<b>Device</b>	<b>C164CI-8R, C164SI-8R, C164CL-8R, C164SL-8R, C164xy-L</b>
<b>Marking/Step</b>	<b>(E)ES-AC, AC</b>
<b>Package</b>	<b>P-MQFP-80-1 (C-MQFP-80: EES-AC only)</b>

This Errata Sheet describes the deviations from the current user documentation. The module oriented classification and numbering system uses an ascending sequence over several derivatives, including already solved deviations. So gaps inside this enumeration can occur.

**Figure 1 SSCTB Timing**

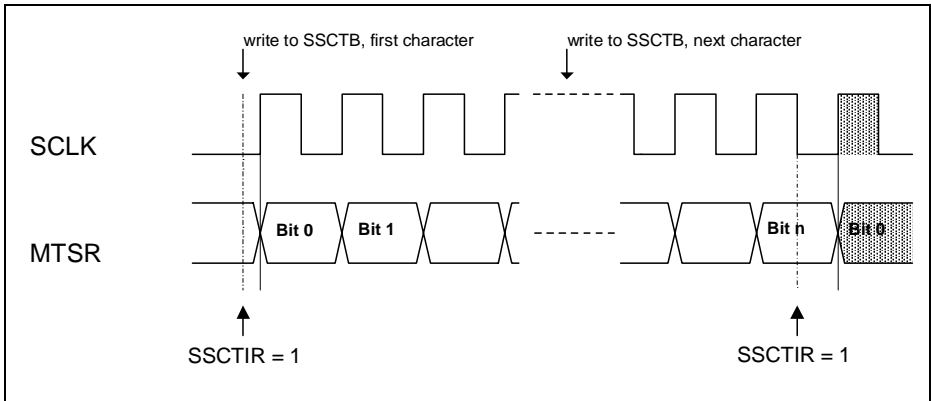
### **SSC.H2 Timing of flag SSCTIR (SSC Transmit Interrupt Request)**

In master mode, the timing of SSCTIR is as follows:

When SSCTB has been written while the transmit shift register was empty (and the SSC is enabled), flag SSCTIR is set to '1' directly after completion of the write operation, independent of the selected baud rate. When the transmit shift register is not empty when SSCTB was written, SSCTIR is set to '1' after the last latching edge of SCLK (= 1/2 bit time before the first shifting edge of the next character). See also e.g. C167CR User's Manual V3.1, p. 12-5.

The following diagram shows these relations in an example for a data transfer in master mode with SSCPO = 0 and SSCPH = 0. It is assumed that the transmit shift register is empty at the time the first character is written to SSCTB:

Typically, in interrupt driven systems, no problems are expected from the modified timing of flag SSCTIR. However, when flag SSCTIR is polled by software in combination with other flags which are set/cleared at the end or at the beginning of a transfer (e.g. SSCBSY), the modified timing may have an effect.

Another situation where a different system behaviour may be noticed is the case when only one character is transferred by the PEC into the transmit buffer register SSCTB. In this case, 2 interrupt requests from SSCTIR are expected: the 'PEC COUNT = 0' interrupt, and the 'SSCTB empty' interrupt:

When the PEC transfer is performed with sufficient margin to the next clock tick from the SSC baud rate generator, and no higher priority interrupt request has occurred in the meantime, the 'PEC COUNT = 0' interrupt will be acknowledged before the 'SSCTB empty' interrupt request is generated, i.e. two interrupts will occur based on these events. However, when the PEC transfer takes place relatively close before the next clock tick from the SSC baud rate generator, or a higher priority interrupt request has occurred while the PEC transfer is performed, the 'PEC COUNT = 0' interrupt may not be acknowledged before the 'SSCTB empty' interrupt request is generated, such that effectively only one interrupt request will be generated for two different events.

In order to achieve a defined and systematic behavior with all device steps, the SSC receive interrupt, which is generated at the end of a character transmission, may be used instead of the SSC transmit interrupt.

**Figure 2 Reset Configuration Source Selection**

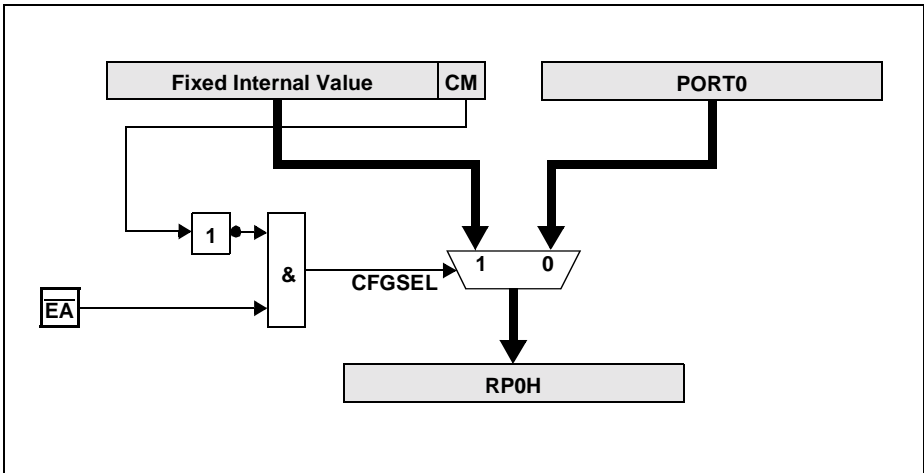
In contrast to the user's manual in the C164CI-8R the register RSTCON is not available. After single-chip mode reset the register RP0H is not set to the described default value but shows the configuration defined in the ROM mask (Configuration Byte) as follows.

For a single-chip mode reset (indicated by  $\overline{EA} = 1$ ) the configuration via PORT0 can be replaced by a fixed configuration value. This fixed configuration value is hardwired and is selectable for each ROM mask. In this case PORT0 needs no external circuitry (pullups/pulldowns) and also the internal configuration pullups are not activated.

The logic described in the figure above controls the reset configuration source (see signal CFGSEL) in the following way:

**Figure 3 Internal Reset Configuration Byte**

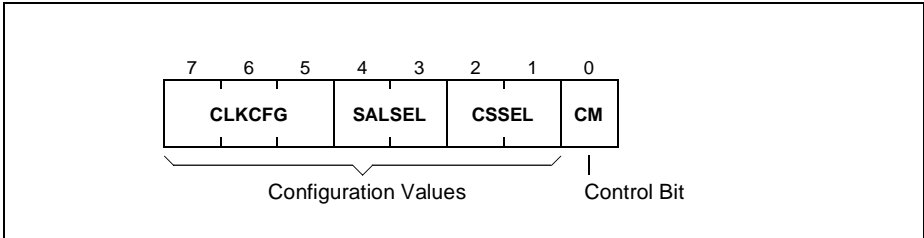
The fixed internal value and the compatibility mode control bit CM for the Single-Chip reset are specified by a byte value described below. This byte value shall be stored at location 00'003E<sub>H</sub> within the user ROM code.
